# Service Bulletin

**Subject:** Engine Oil Consumption on Aluminum Block/Iron Block Engines with Active Fuel Management (AFM)  
(Install AFM Oil Deflector and Clean Carbon from Cylinder and/or Install Updated Valve Cover)

**Models:** 2007-2011 Cadillac Escalade Models  
2007-2011 Chevrolet Avalanche, Silverado 1500, Suburban, Tahoe  
2010-2011 Chevrolet Camaro  
2007-2011 GMC Sierra 1500, Sierra Denali, Yukon Models  
2008-2009 Pontiac G8 GT  
Built Prior to February 1, 2011 (Updated Valve Cover) and October 2010 (AFM Shield)  
Equipped with Any of the Following Engines:  
– Aluminum Block V8 Engine with Active Fuel Management (AFM) (RPOs L94, LZ1, L99, LC9, LH6, L76, L92, LFA (Hybrid))  
– Iron Block V8 Engine with Active Fuel Management (AFM) (RPOs LMG, LY5)

*This bulletin is being revised to update the build date and Parts Information. Please discard Corporate Bulletin Number 10-06-01-008G (Section 06 – Engine/Propulsion System).*

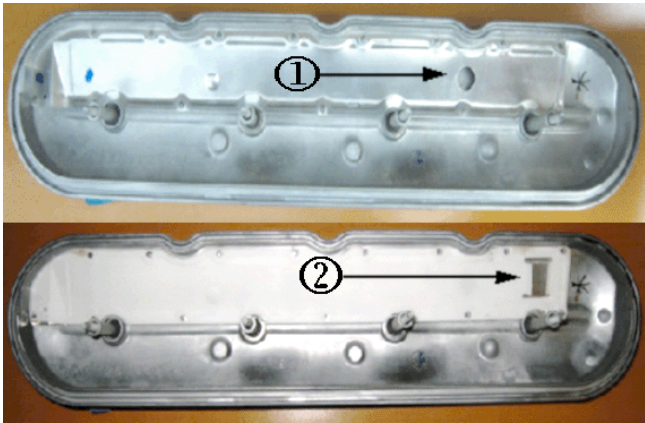
1) Old Design

2) New Design

PCV pullover or an overactive lifter can cause oil to be pulled through the PCV system even at low vehicle mileage. A correctly functioning PCV system will only leave a film of oil in the intake manifold. Inspect the intake manifold to see if there is any oil puddling in the bottom. If there is you will need to replace the left valve cover. Two new left rocker arm covers have been released for trucks and vans. Technicians should replace the left rocker arm cover with GM P/N 12570427 for 2007-2008 or GM P/N 12642655 for 2009-2011. Refer to the Parts Information below for the Camaro. This rocker arm cover has a relocated PCV drain hole that prevents oil from entering the intake manifold. Refer to Valve Rocker Arm Cover Replacement - Left Side in SI.

**Note:** These rocker covers are for specific years. The PCV orifice is different for each. The correct cover must be used or an SES light may set.

### Aluminum Block - Oil Getting Past Piston Rings - Free Up Piston Rings and Install AFM Shield on All Non-Hybrid Models Built Prior to October 1, 2010 or all Hybrid Models Built July 7, 2009 - October 1, 2010

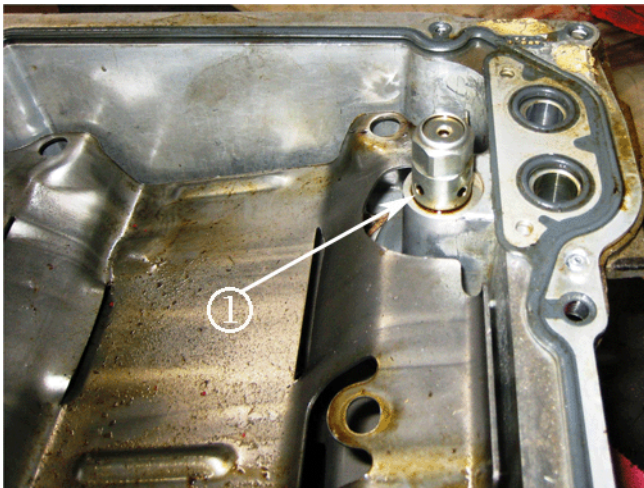
**Note:** If vehicle is built outside of this breakpoint, it should already be equipped with this AFM shield or the pan does not have an AFM valve (LFA before July 7 2009).

To correct this condition, install an AFM shield, perform the piston cleaning procedure as described in this document and install a new oil pan gasket per the procedure outlined in this document. Monitor oil consumption after this repair to ensure oil consumption has improved to acceptable levels.

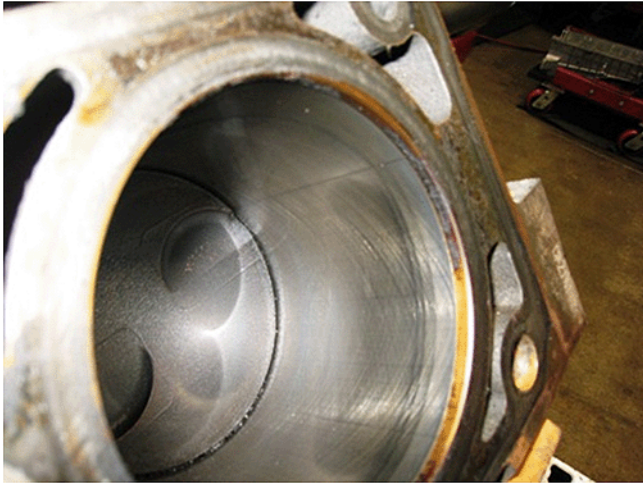
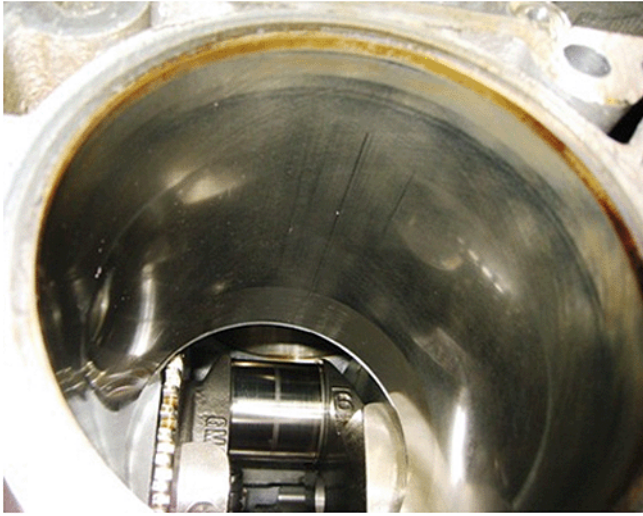
4. Remove the AFM valve (1).

5. Install the new shield (1), GM P/N 12639759, and tighten the AFM valve to the oil pan to 28 Y (20 lb ft).
